# RECOMMENDATION PACKET

3040554-LU | 2115 N 45th Street Seattle, WA

Along the vibrant N 45th Street pedestrian corridor, the 14,204 SF project site, is located in the Wallingford Urban Village with access to frequent transit options.

# EDG RESPONSE - MASSING (8.0)

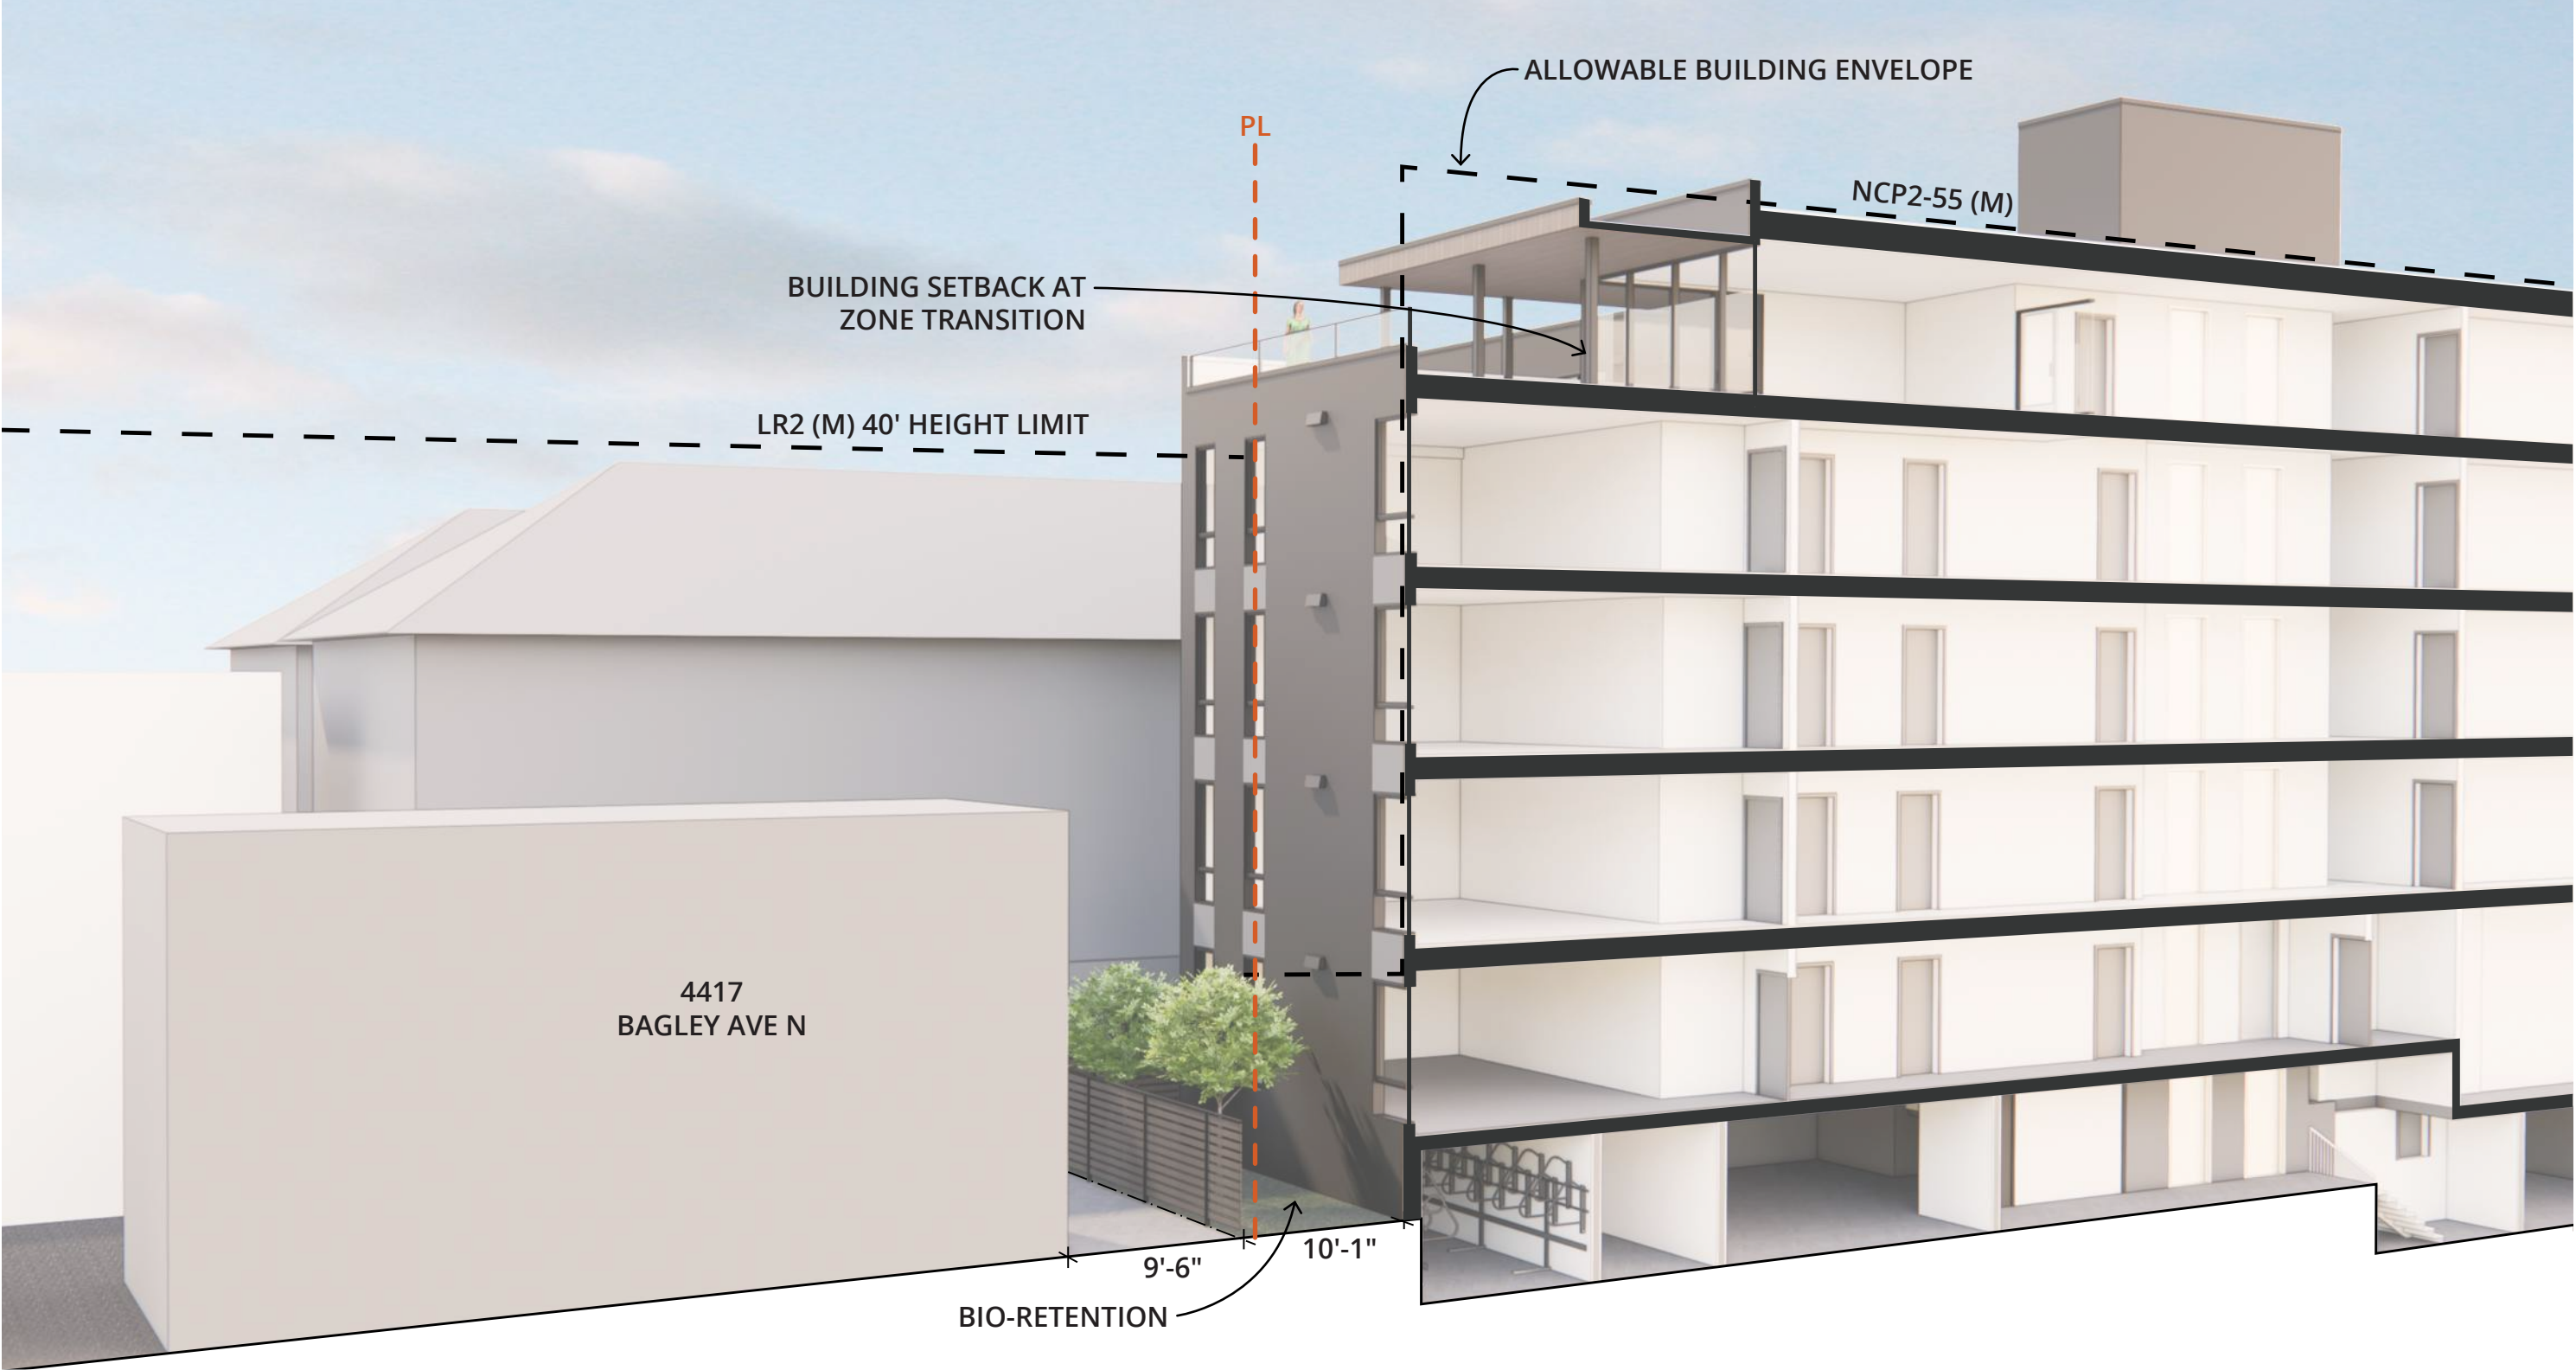
The Board supported the applicant's preferred architectural massing option, Option C. The Board appreciated Option C for its central massing modulation that respects the established structure width pattern, slightly recessed top floor with defined columns framing bays, and recessed base that helped break down the perceived height, bulk, and scale along N 45 th St.

**The Design Review Recommendation Meeting massing is consistent with the proposed Option C Early Design Guidance massing and maintains the central modulation, recessed ground floor, and takes cues from the contextual fabric patterns.**

- A** Grid
- B** Slightly Recessed Top Floor
- C** Recessed Base

## EDG RESPONSE - GROUND LEVEL USES (8.0)

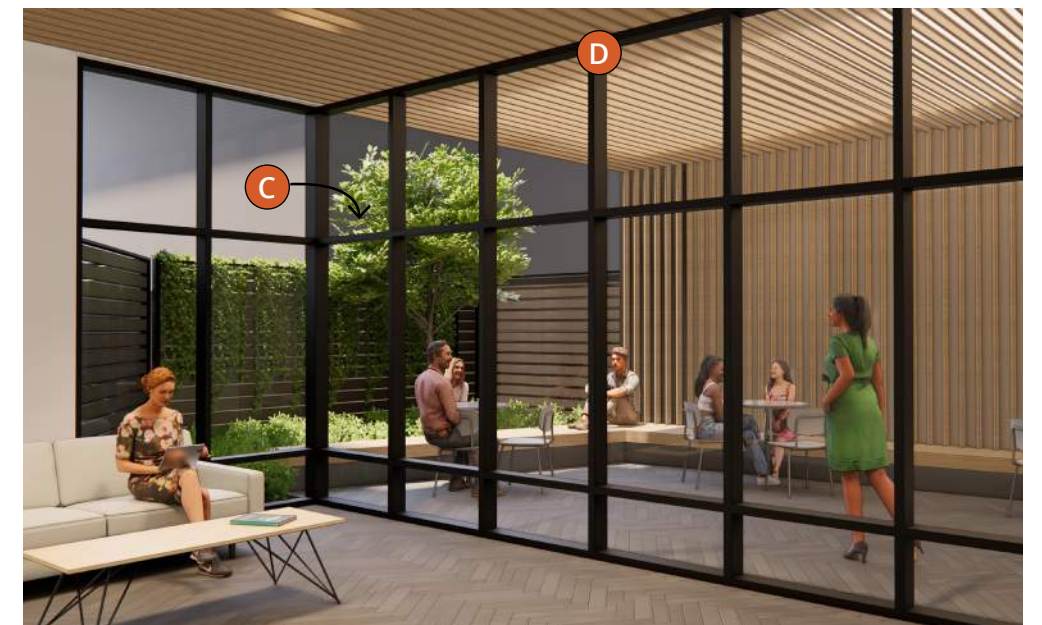
The Board appreciated the centrally located pass-through on N 45th St proposed in massing Option C that bisected the retail into appropriately sized spaces. The Board noted this reinforced the sidewalk edge while still providing exterior area that could allow for interaction between residents, pedestrians, and the retail uses. The Board gave guidance for the applicant to carefully consider public safety and balance public access into the space during business hours through the use of appropriate lighting levels and adequate transparency from the retail spaces to allow for eyes on the space.

The proposal is consist with EDG massing  
Option C maintaining the centrally located  
'muse' (pass-through).

- A A decorative gate at the entrance will be open during retail hours.
- B The ground floor consists of high quality materials (storefront, brick, wood soffit. The muse provides flexible and permanent seating opportunities for the retail and residential amenities. Significant glazing maximizes visibility.
- C A feature tree and landscaping provides a focal feature at the end of the muse.
- D Lighting integrated with the wood soffit continues into the residential amenity to blur the line between interior and exterior.

SERVICE USES  
(DC1-C-4)

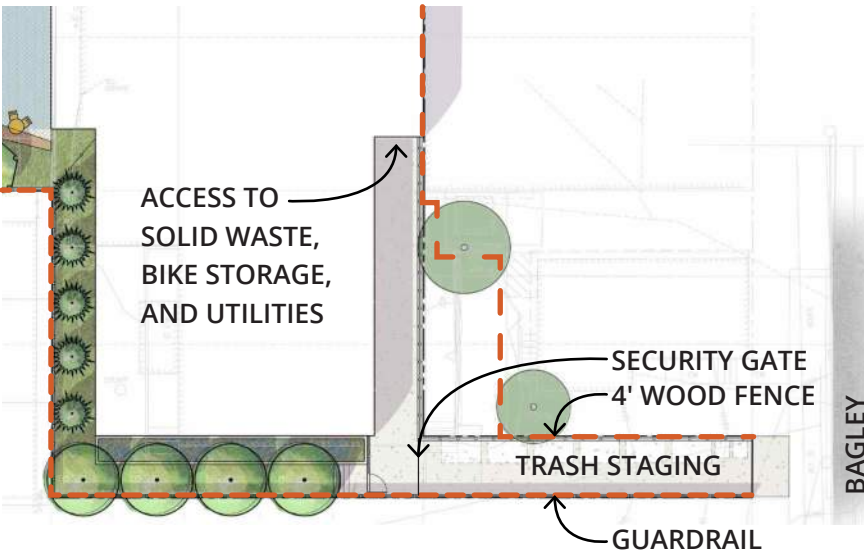
Access and Frontage on Bagley Ave N: 3.a  
The Board noted that solid waste staging was proposed along the thin panhandle piece of property running along the southern property line of the adjacent site and extending to Bagley Ave N and that the path was at a different elevation than the pass-through from N 45th St.

The Board gave guidance for the applicant to maintain this disconnect between the pass-through and the solid waste storage and staging area, and to design the fencing, screening, and gates of this solid waste staging area so that it appears as an integrated part of the overall design. (DC1-C-4)

The solid waste staging is consistent with the proposed EDG layout.

- A Open guardrail along the southern property line to help visibility at neighboring driveway.
- B 4' fence at north property line to screen solid waste staging area.

EDG RESPONSE - ACCESS AND FRONTAGE ON BAGLEY AVE N (8.0)

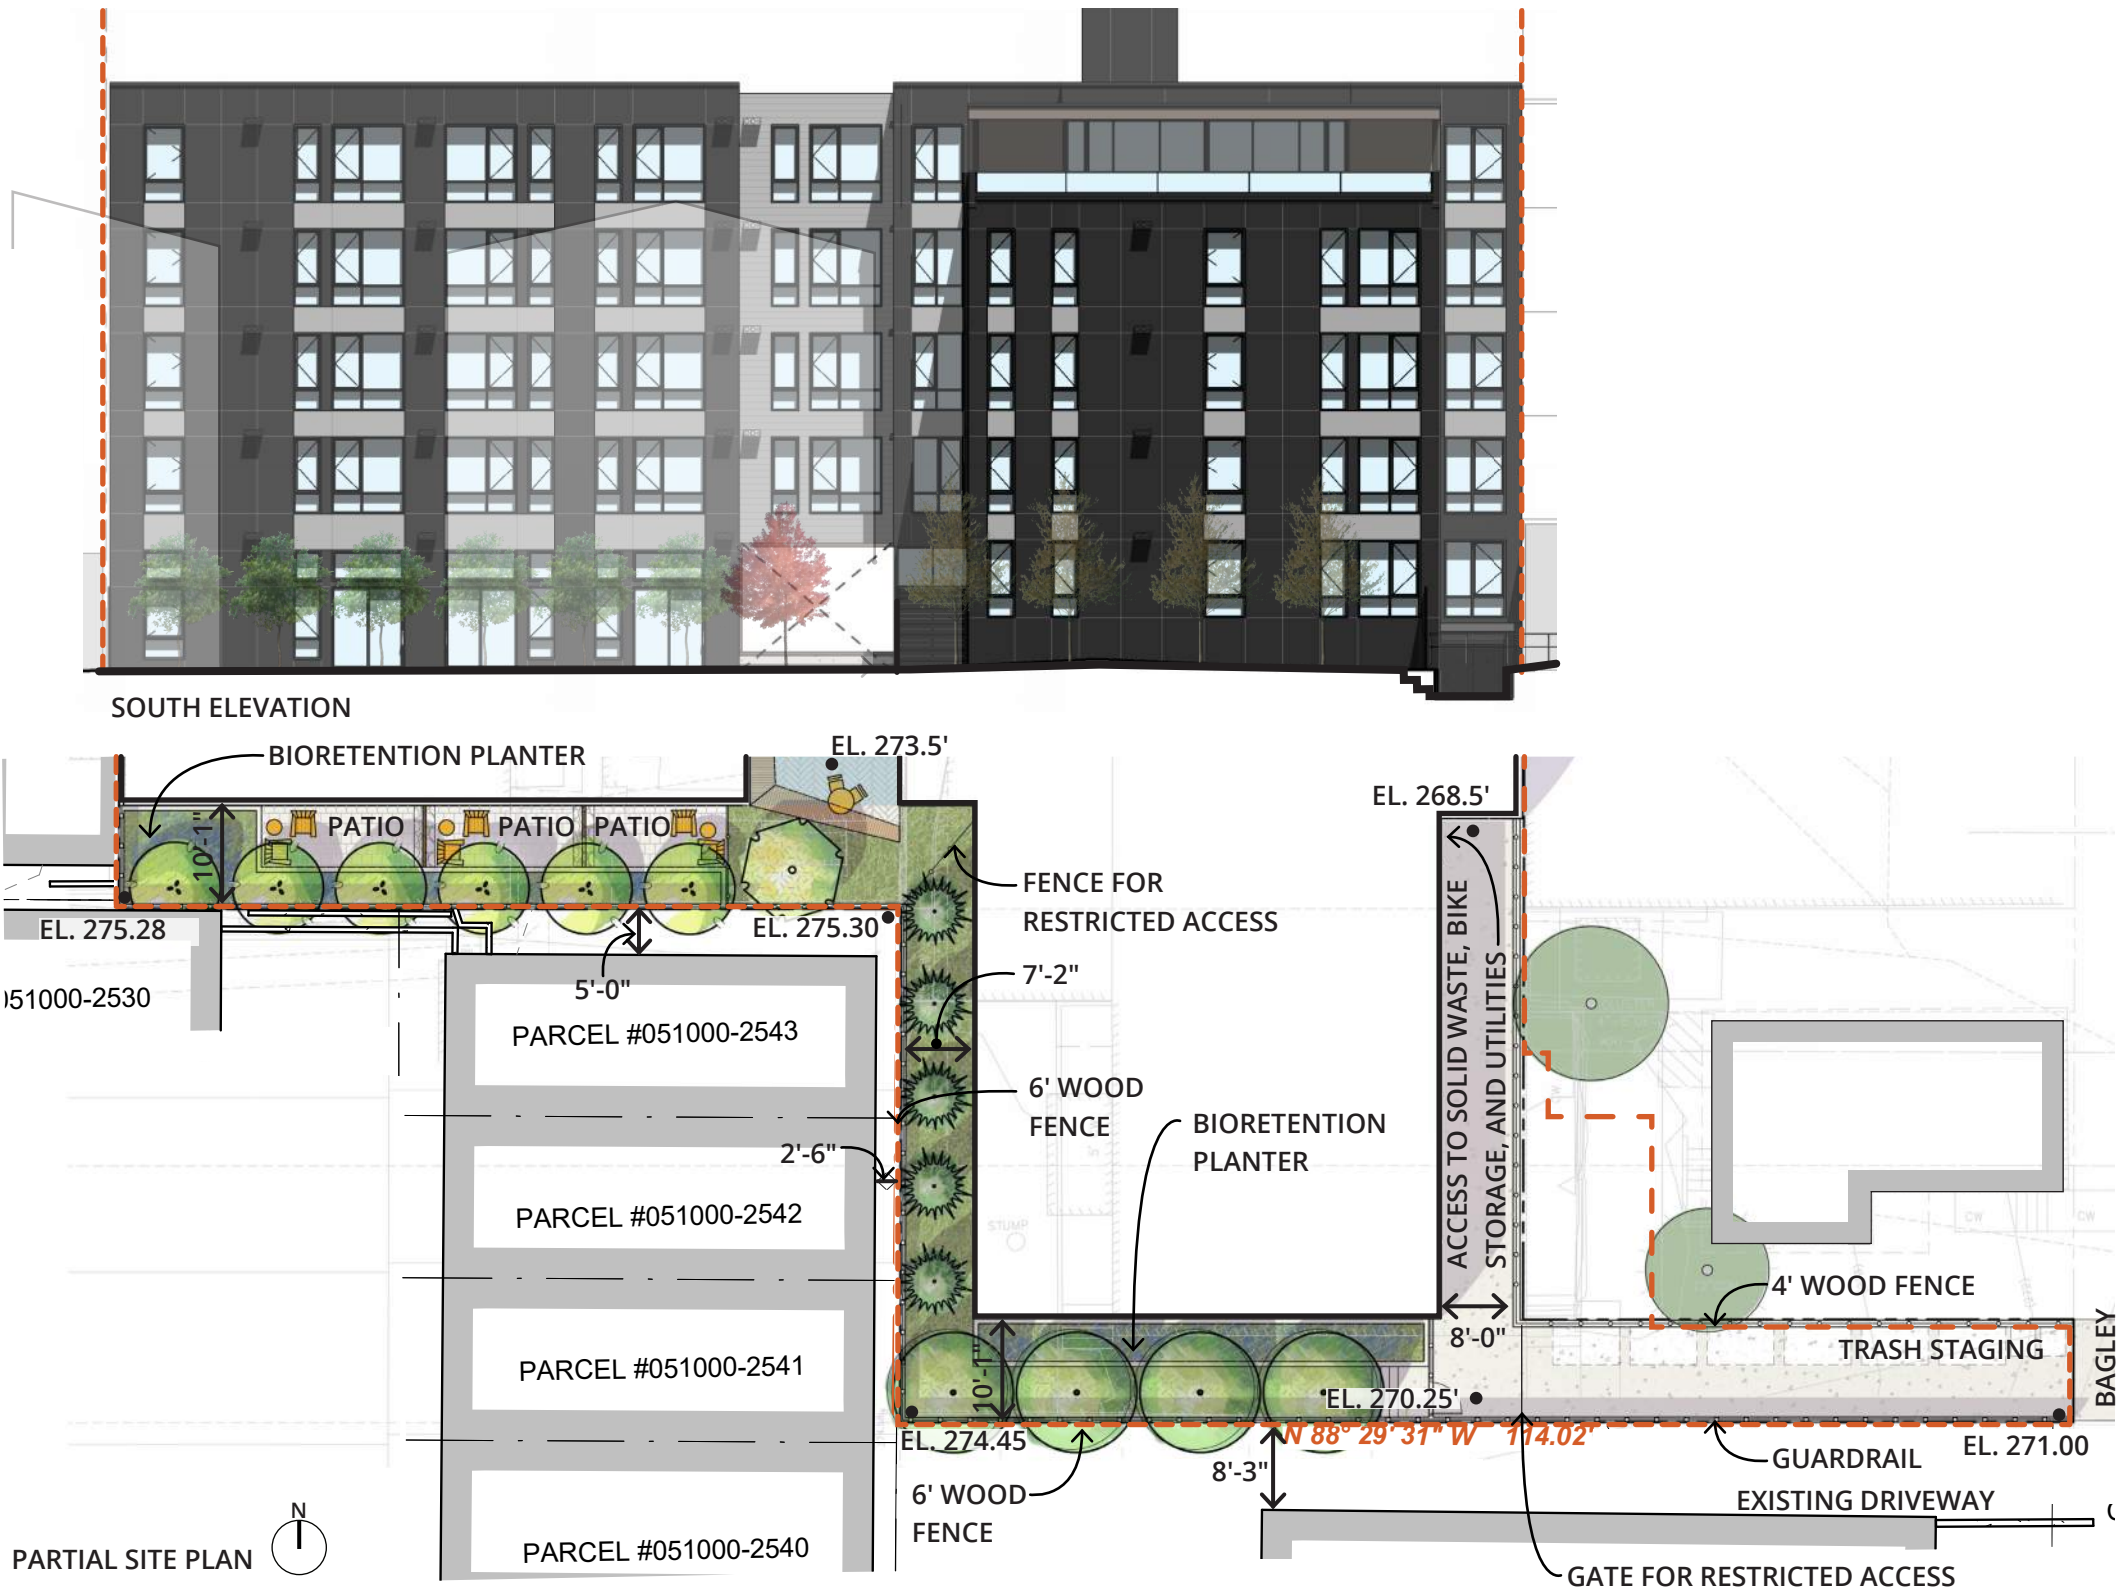
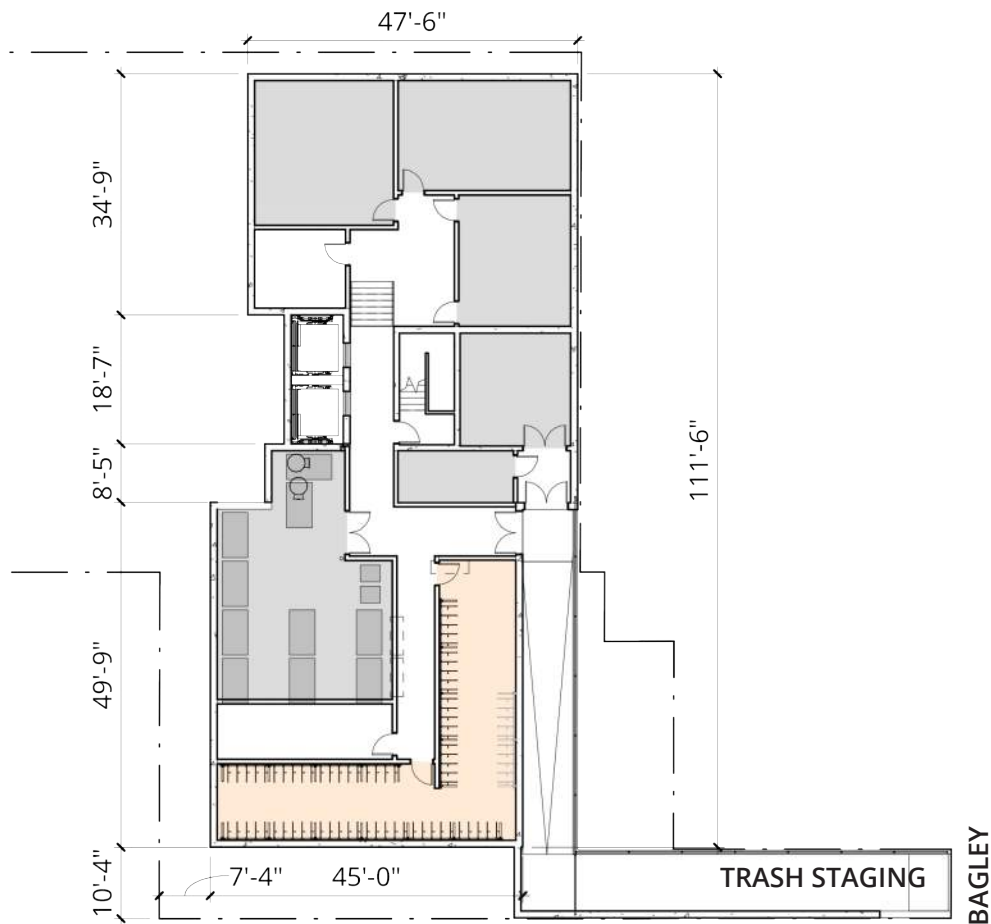
Access and Frontage on Bagley Ave N: 3.a  
The Board noted that solid waste staging was proposed along the thin panhandle piece of property running along the southern property line of the adjacent site and extending to Bagley Ave N and that the path was at a different elevation than the pass-through from N 45th St.

The Board gave guidance for the applicant to maintain this disconnect between the pass-through and the solid waste storage and staging area, and to design the fencing, screening, and gates of this solid waste staging area so that it appears as an integrated part of the overall design. (DC1-C-4)

There is not a public connection from Bagley. There is a fence that restricts access. Bioretention and plantings are programmed at the southern portion of the site with restricted gate access from the trash staging area.
